## Public Input No. 207-NFPA 70-2019 [ Global Input ]

## Public Input No. 259-NFPA 70-2020 [ Global Input ]

**Figure 406.3(E) Controlled Receptacle Marking Symbol.**

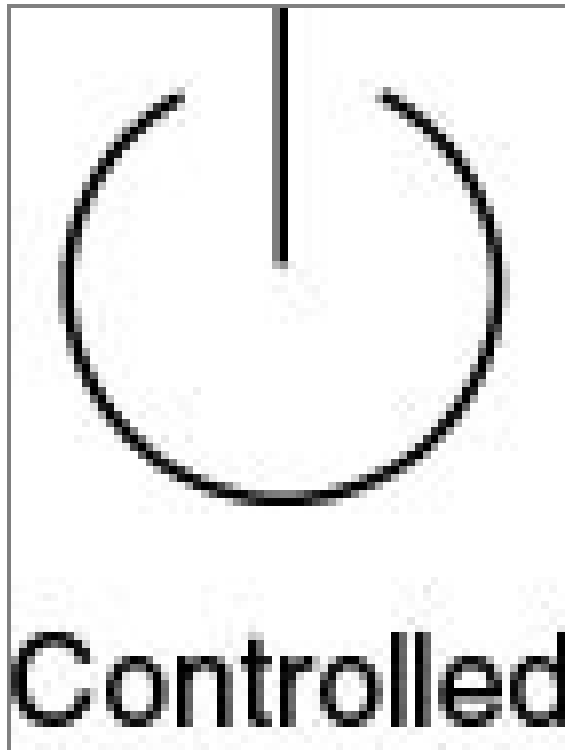
All nonlocking-type, 125-volt, 15- and 20-ampere receptacles that are controlled by an automatic control device, or that incorporate control features that remove power from the receptacle for the purpose of energy management or building automation, shall be permanently marked with the symbol shown in Figure 406.3(E) and the word “controlled.”

For receptacles controlled by an automatic control device, the marking shall be located on the receptacle face and visible after installation.

In both cases where a multiple receptacle device is used, the required marking of the word “controlled” and symbol shall denote which contact device(s) are controlled.

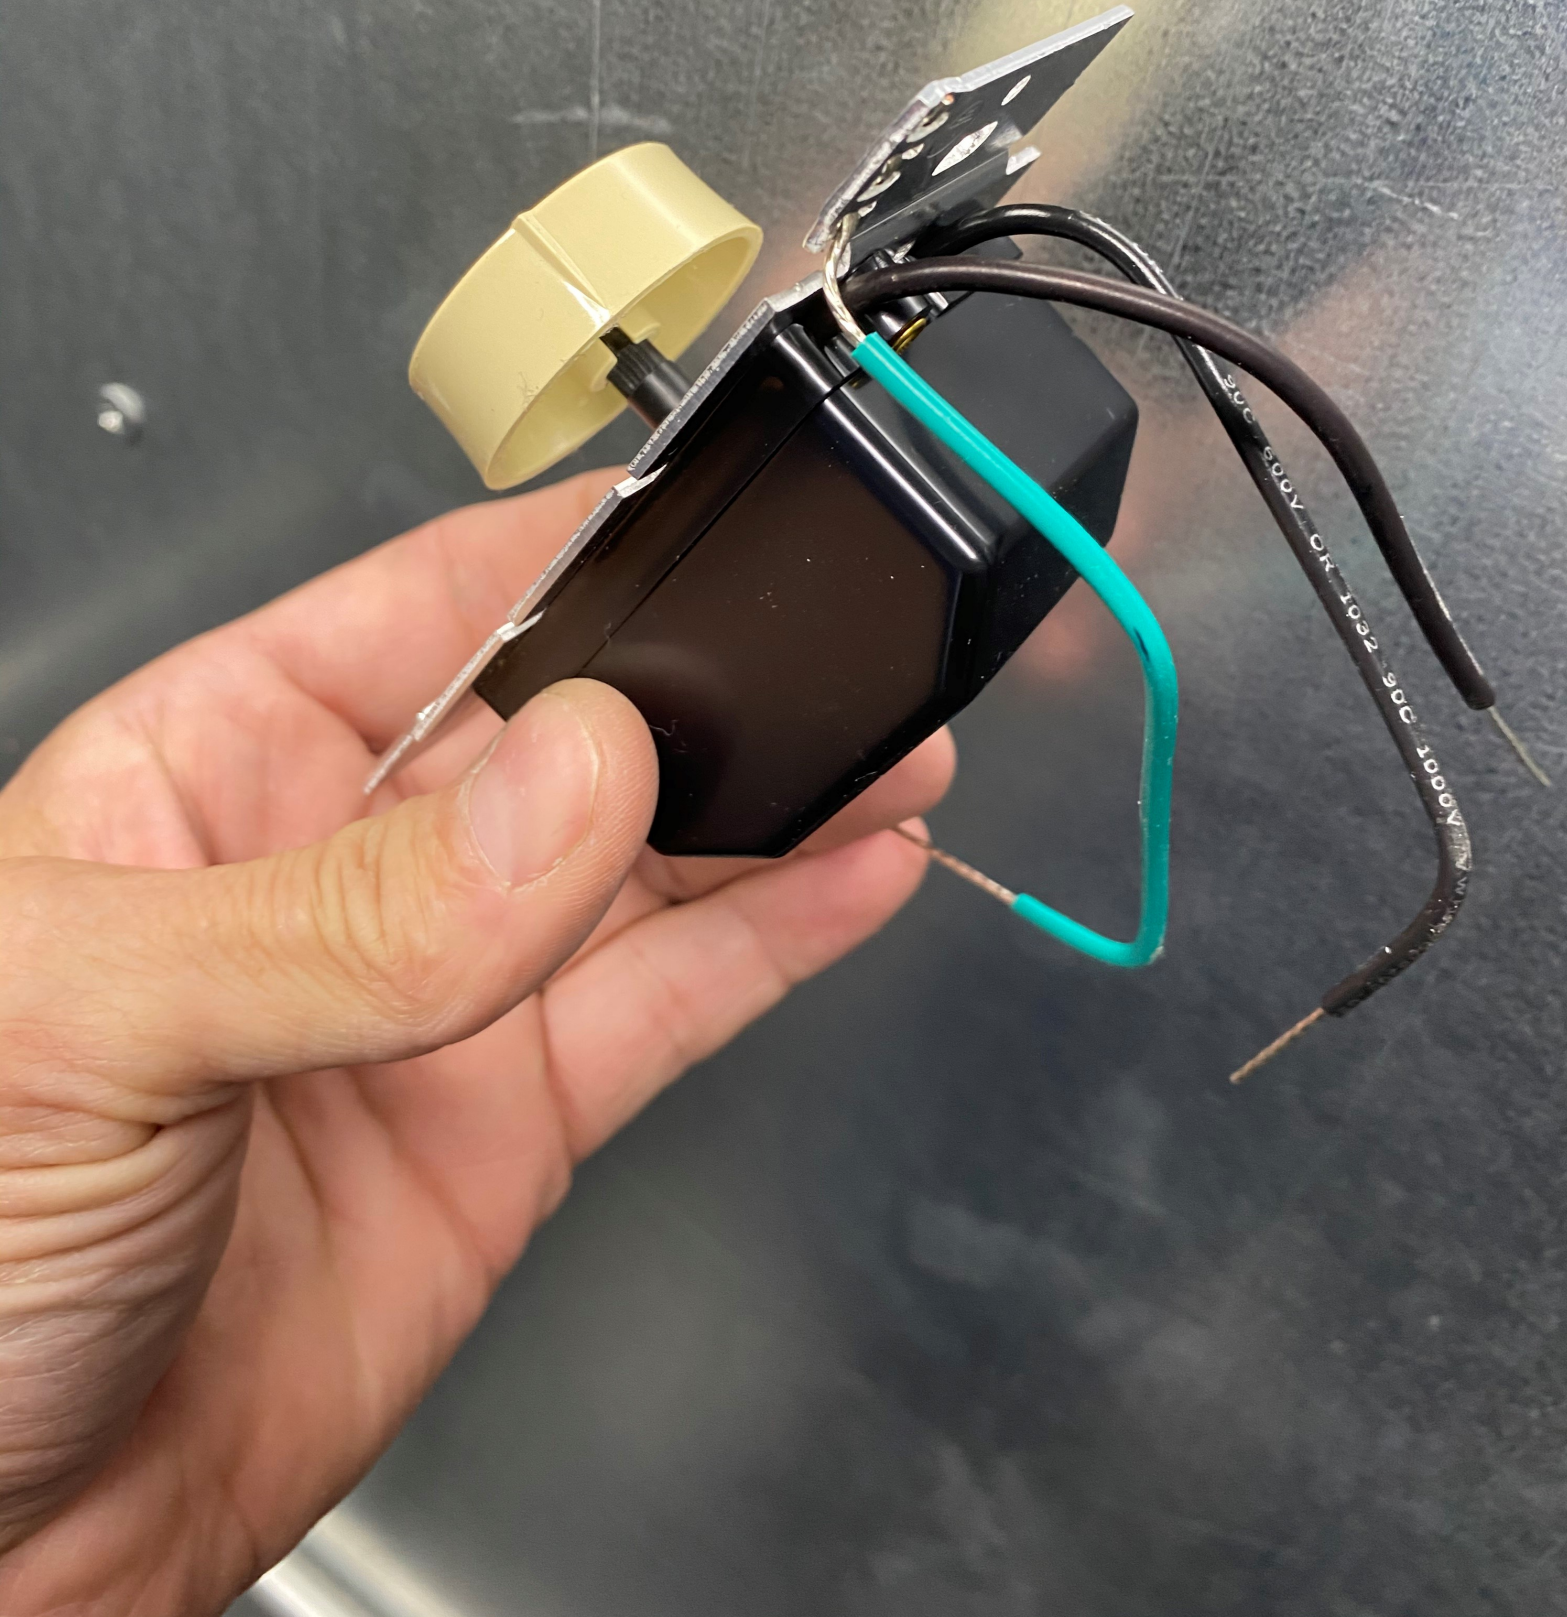
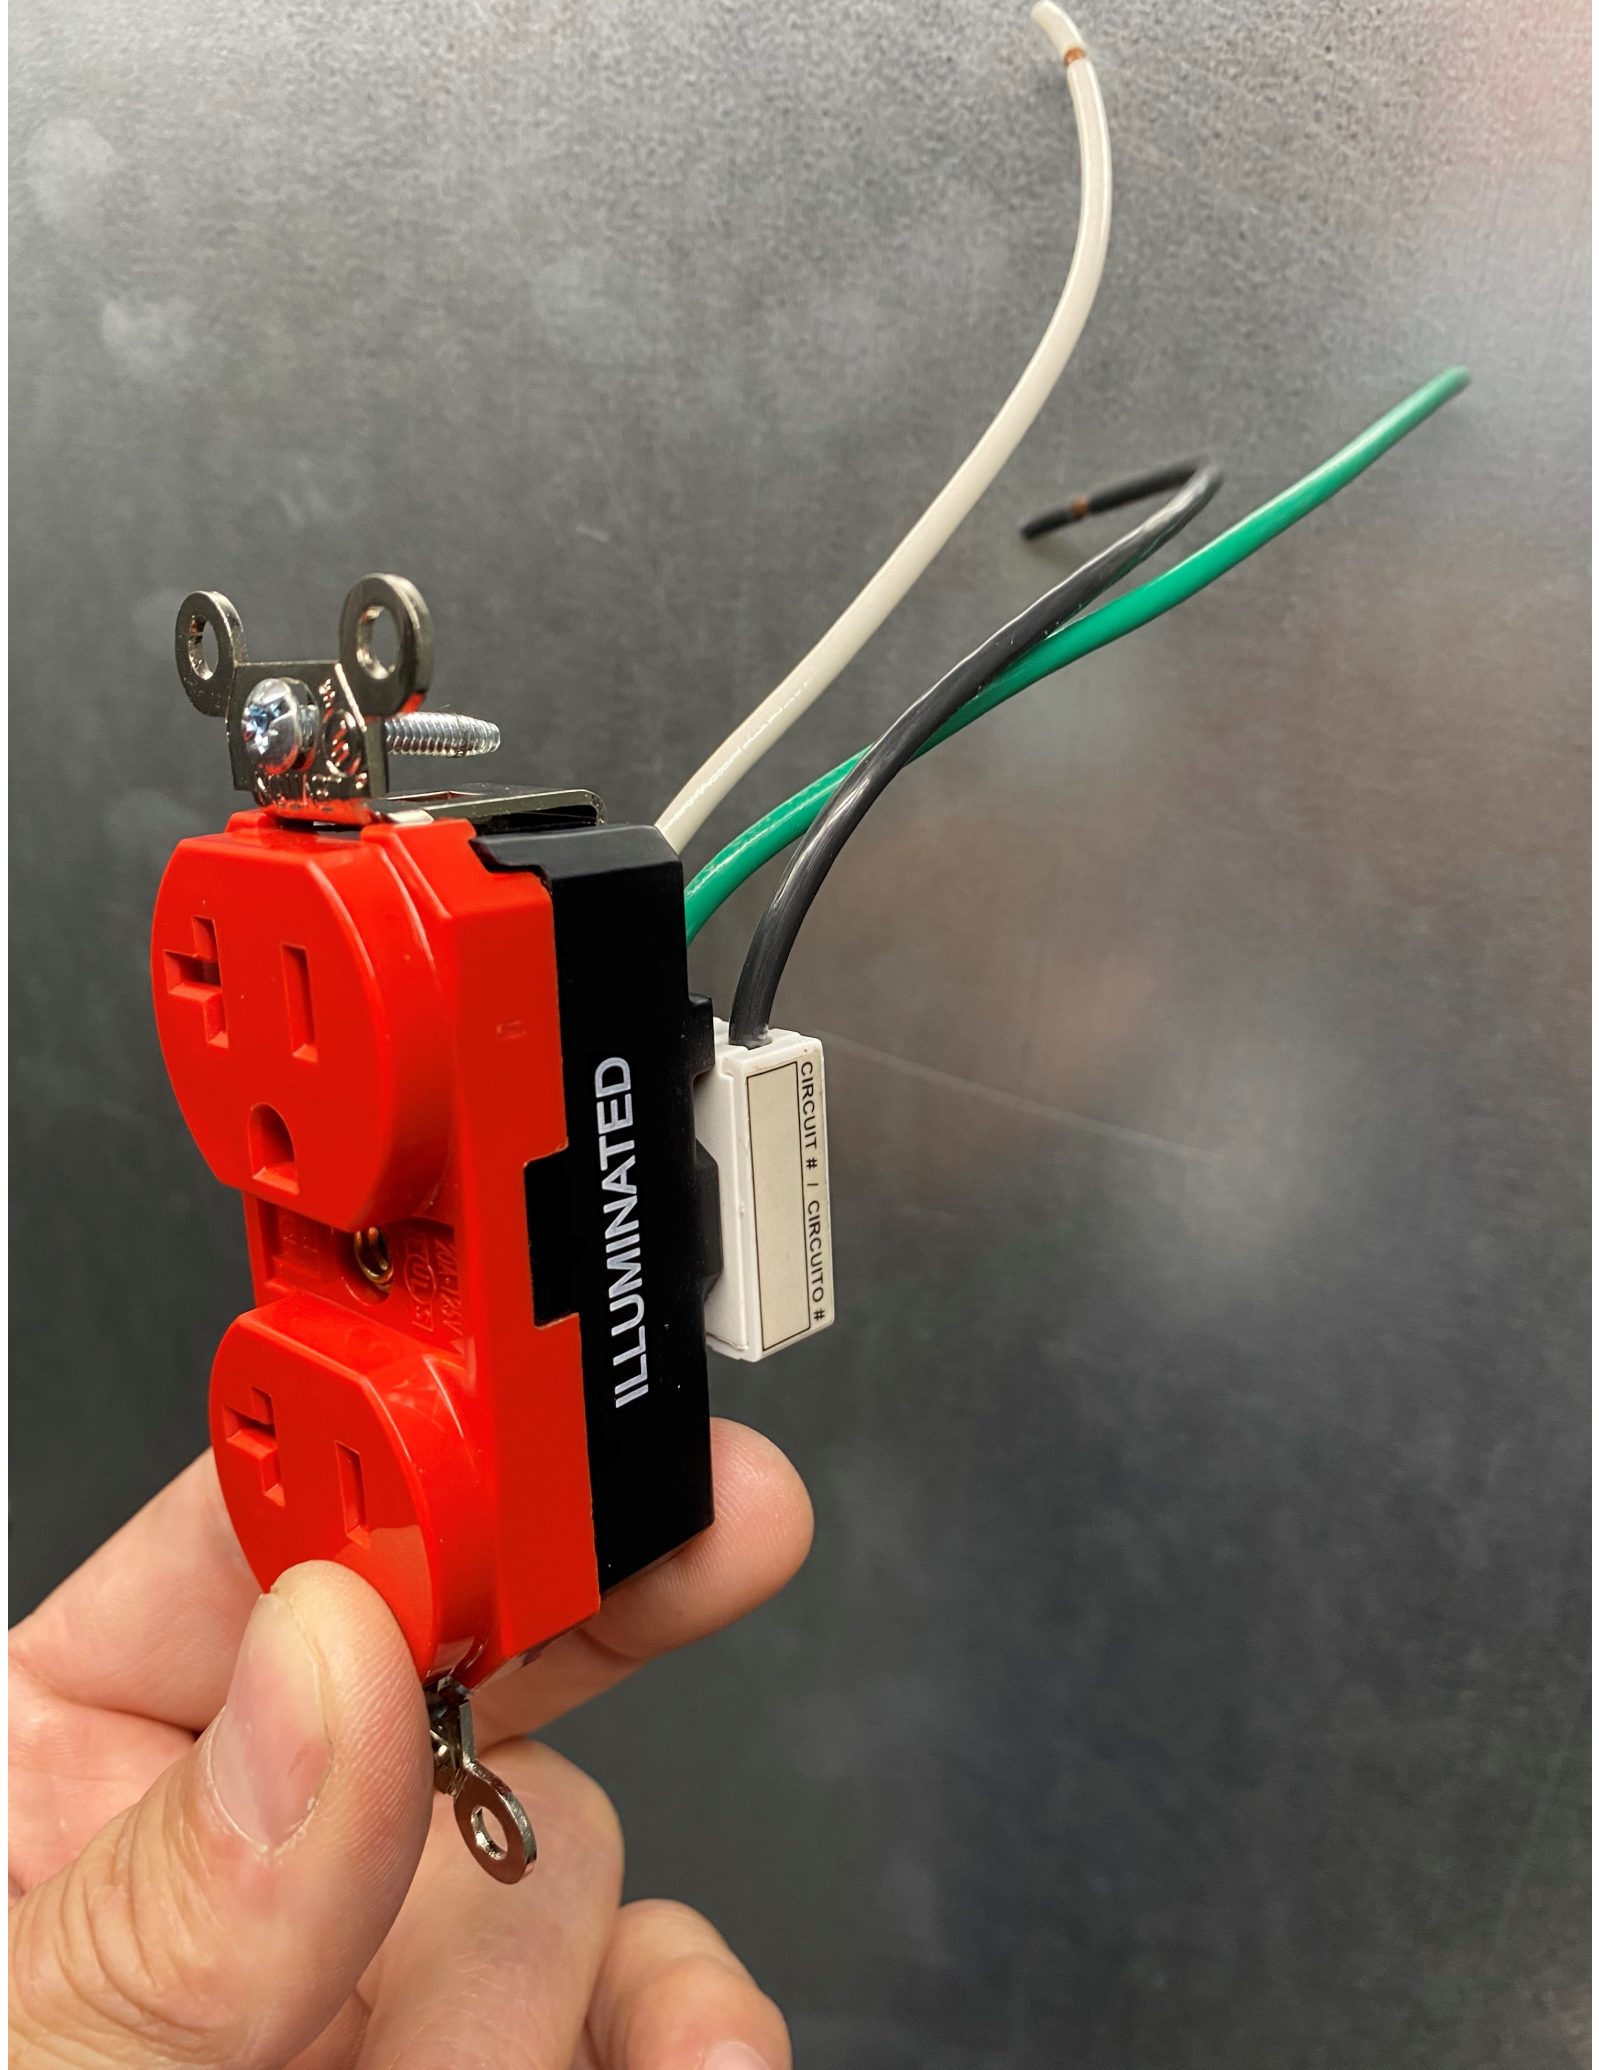
Devices with no exposed terminals effectively have “barriers” built-in as part of the design of the device. These types of devices pose much less of a shock hazard than devices having exposed energized terminals. The risk of an arc between devices is also greatly reduced since there are no exposed terminals. Barriers should not be required where these types of devices are installed.

<u>File Name</u>	<u>Description</u>	<u>Approved</u>
_406.9_C_2023_NEC_.jpg	406.9(C) (2023 NEC) (K Lofland)

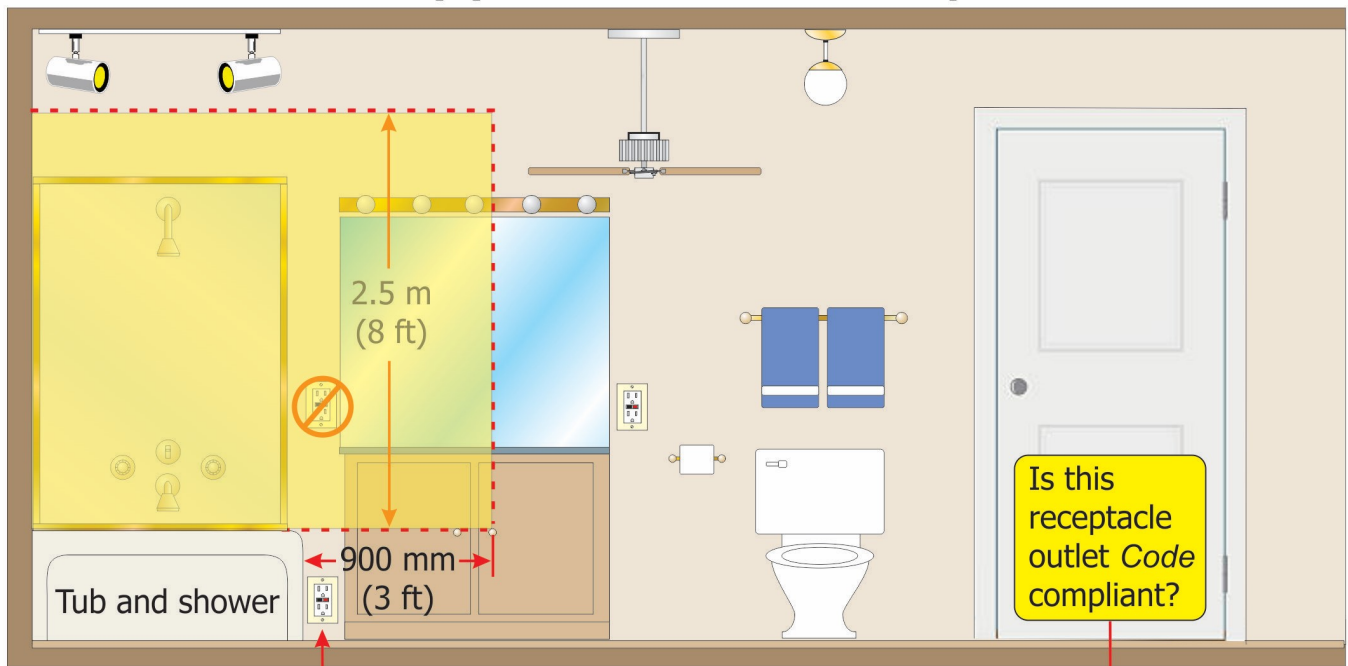
Presently, a "zone" has been established around a tub or shower restricting receptacle outlet placement around tubs and shower stalls. This "zone" for receptacle outlets in Article 406 was patterned after the existing "zone" for luminaires at 410.10(D). It would be logical to assume that a luminaire or ceiling fan would not be located below this restrictive zone which extends 3 ft. out and 8 ft. tall from the bathtub rim. The logic would not hold true for the placement of a receptacle outlet below this restrictive zone. Nothing in the 2020 NEC would prevent a 125-volt, 20 ampere receptacle outlet from being installed on the front of the bathroom cabinet located 3 in. from the tub and 1 in. below the bathtub rim (below and outside of the restrictive zone). Would this receptacle outlet located about 18 in. off the floor be convenient...maybe not, but it would be Code complaint. I question if this was the intent of CMP-18 for the restriction of receptacle outlets around tubs for the 2020 NEC.

<u>File Name</u>	<u>Description</u>	<u>Approved</u>
_406.9_C_2023_NEC_.jpg	406.9(C) (2023 NEC) (K Lofland)

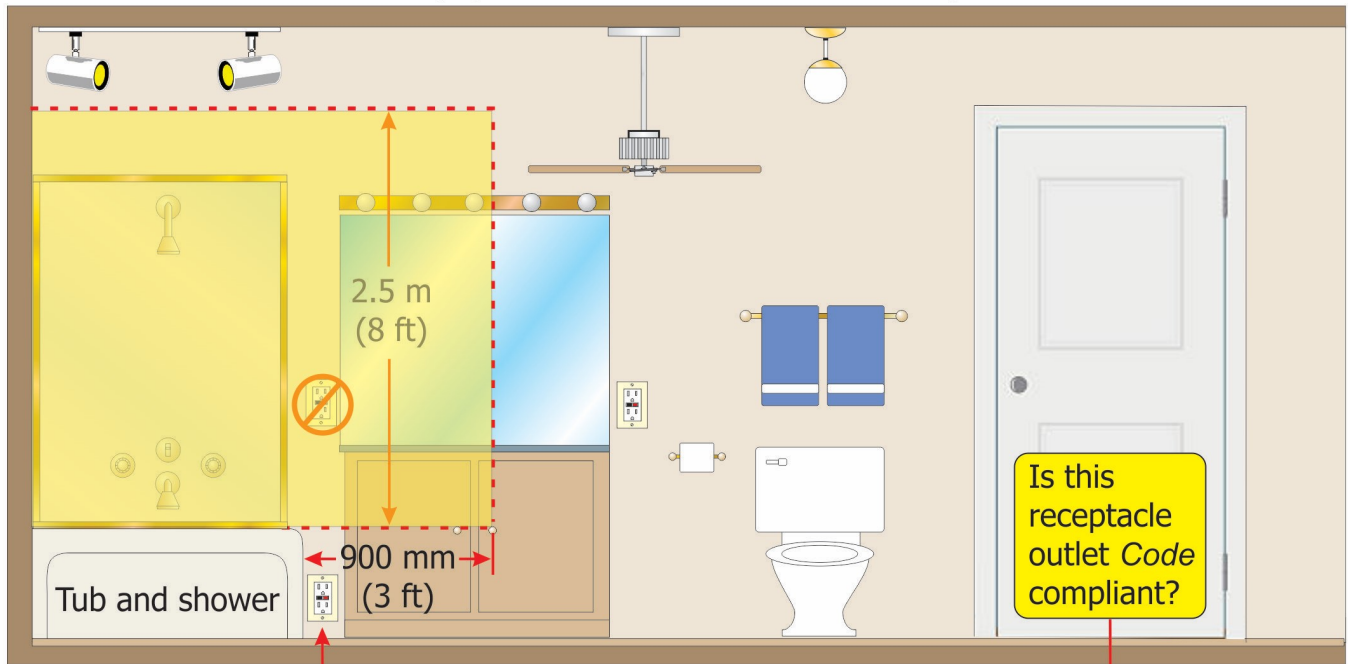
Presently, a "zone" has been established around a tub or shower restricting receptacle outlet placement around tubs and shower stalls. This "zone" for receptacle outlets in Article 406 was patterned after the existing "zone" for luminaires at 410.10(D). It would be logical to assume that a luminaire or ceiling fan would not be located below this restrictive zone which extends 3 ft. out and 8 ft. tall from the bathtub rim. The logic would not hold true for the placement of a receptacle outlet below this restrictive zone. Nothing in the 2020 NEC would prevent a 125-volt, 20 ampere receptacle outlet from being installed on the front of the bathroom cabinet located 3 in. from the tub and 1 in. below the bathtub rim (below and outside of the restrictive zone). Would this receptacle outlet located about 18 in. off the floor be convenient...maybe not, but it would be Code complaint. I question if this was the intent of CMP-18 for the restriction of receptacle outlets around tubs for the 2020 NEC.

**Figure 410.2 Clothes Closet Storage Space.**

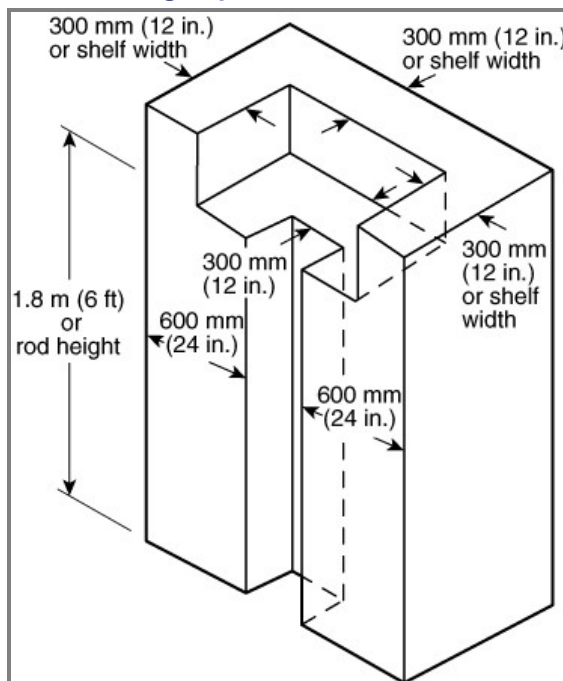
Unless there are doors enclosing each storage or hanging space, The volume bounded by the sides and back closet walls and planes extending from the closet floor vertically to a height of 1.8 m (6 ft) or to the highest clothes-hanging rod and parallel to the walls at a horizontal distance of 600 mm (24 in.) from the sides and back of the closet walls, respectively, and continuing vertically to the closet ceiling parallel to the walls at a horizontal distance of 300 mm (12 in.) or the width of the shelf, whichever is greater; for a closet that permits access to both sides of a hanging rod, this space includes the volume below the highest rod extending 300 mm (12 in.) on either side of the rod on a plane horizontal to the floor extending the entire length of the rod. See Figure 410.2.

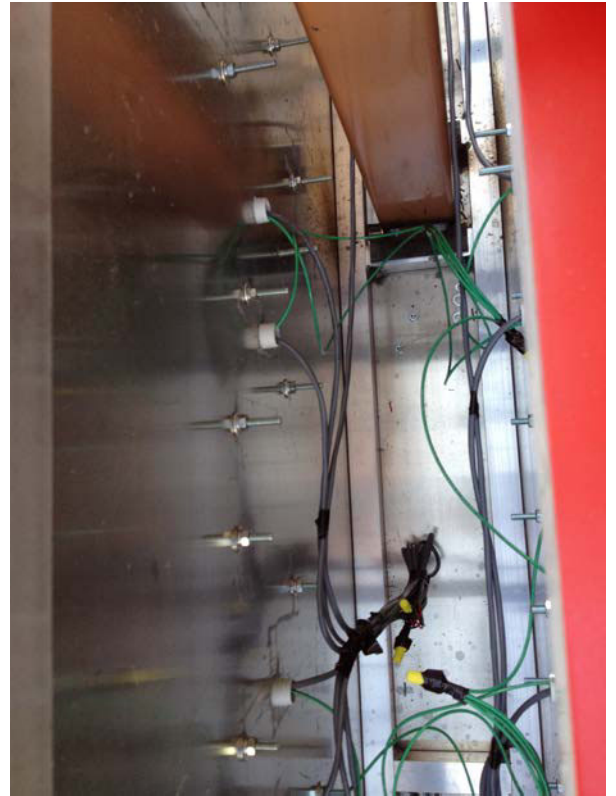
1. The Code language does not address listed enclosures for Ballast, Electronic Power Supplies, and Class 2 Power Sources or a metal constructed sign enclosure as described in section 600.8. The AHJ is left to interpret neon transformer enclosures as the only type allowed to contain both branch and secondary circuit conductors that can supply adjacent signs, outline lighting, or floodlights. A listed Ballast, Electronic Power Supply, Class 2 Power Supply or metal sign enclosure are all installed under the same conditions but the AHJ is left to deny the installation because of the code language as written.

2. Adding the language of "all ungrounded" promotes consistency of disconnecting means language used in section 600.6. Also, if a neutral conductor installed as required in section 200.4(A) and cannot be used for more than one branch circuit which is the typical installation for most signs, language that states "de-energizes all current carrying conductors", is not applicable.
